To: Richard Collier, McKim & Creed
From: Brian Chambers, Senior Planner; 910.342.2782
CC: File;
Date: 9/28/2022
Re: Center Point TRC Rev 5

Project Name: Centerpoint
Response Date: 09/16/2022
Reviewer: Eric Seidel, PE
Department: Engineering – Plan Review Section

Project Name: **CENTERPOINT**

Formal TRC #5 Date: **09.20.2022**

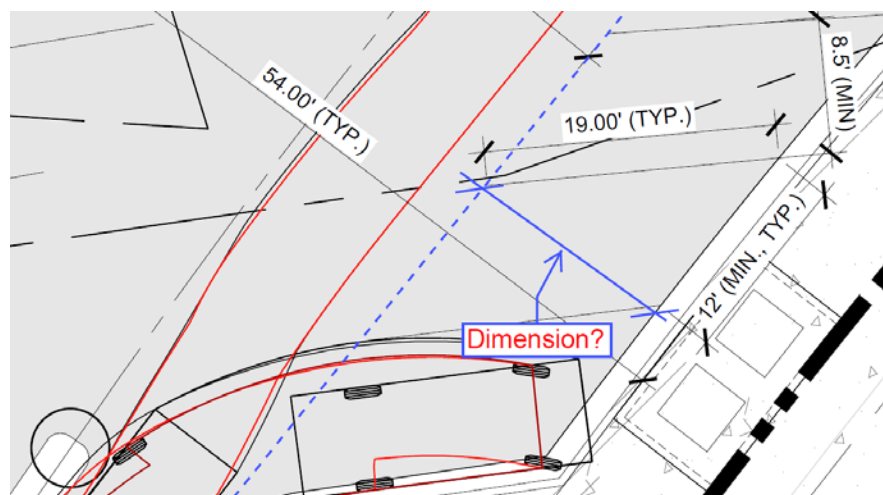
1. City's 20'x70' sight distance triangle is not required at the street (Private/public ROW) intersections. Instead show 46'x46'.
2. Clarify the requirement of 30'x70' sight distance triangle shown on sheet CR-101.
3. 46'x46' SDT are still called out at the roundabout on sheet CS-101.
4. Dimension the angle of angled parking spaces on site plan as per [Chapter VII, Table 6, page 7-19 CofW TSSM].
5. Angled parking spaces dimensions must meet minimum requirements for parking from City Technical Standard, [Chapter VII, Table 6, page 7-19 CofW TSSM]. 19' minimum is measured from rear to front of stall perpendicularly to curb for 45-degree spaces. A waiver at SRB was to allow angled on-street parking subject to be built as per City technical standards. Auto turn shows insufficient length proposed. Look for blue markups in an image below.
